BOLLETTINO DI SERVIZIO
SERVICE BULLETIN

NO. **368**
NB.

DATE : 28-07-97
MODELS AFFECTED : ALL ELECTRIC TYRE CHANGERS (EXCEPT MONTY)
SUBJECT : TURNTABLE CYLINDERS - NEW TYPE

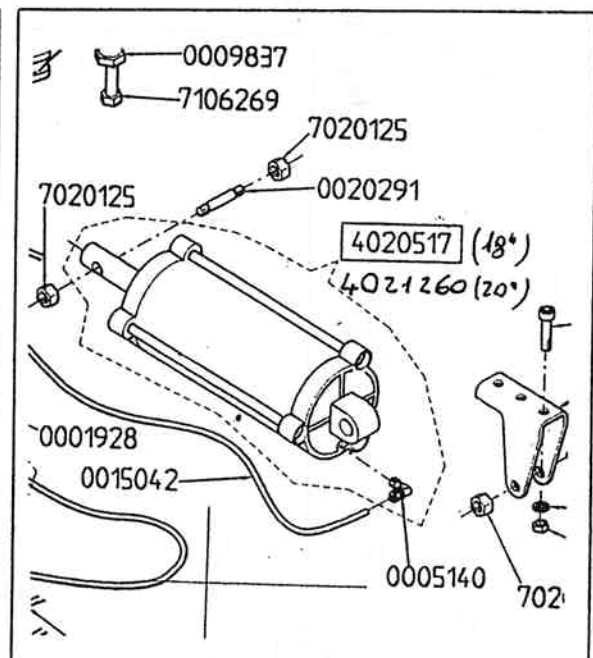
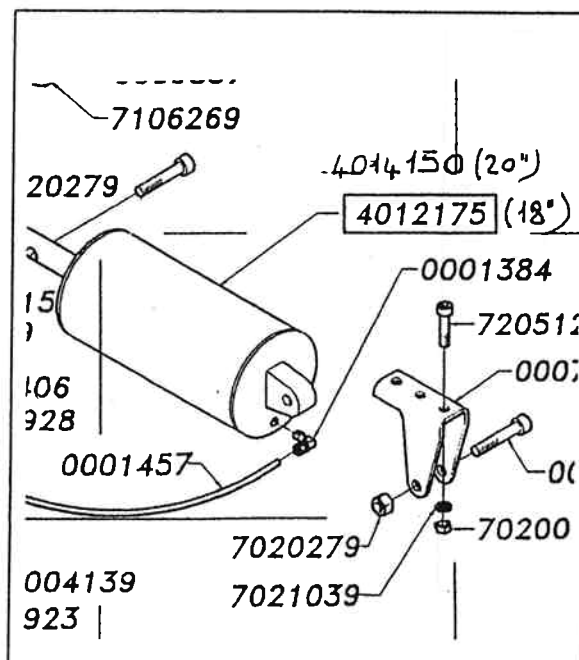
Turntable cylinders #4012175 (18") and #4014150 (20") have been replaced respectively by new cylinders #4020517 (18") and #4021260 (20"), which can easily be recognized by presence of 3 tension rods.

New cylinders are bigger than the old ones. The shape of manifold has been modified consequently, code number remains unchanged.

- OLD CYLINDERS CAN BE FITTED ON NEW MACHINES, WHILE NEW CYLINDERS CANNOT BE MOUNTED ON OLD MACHINES, UNLESS THE MANIFOLD IS ALSO REPLACED
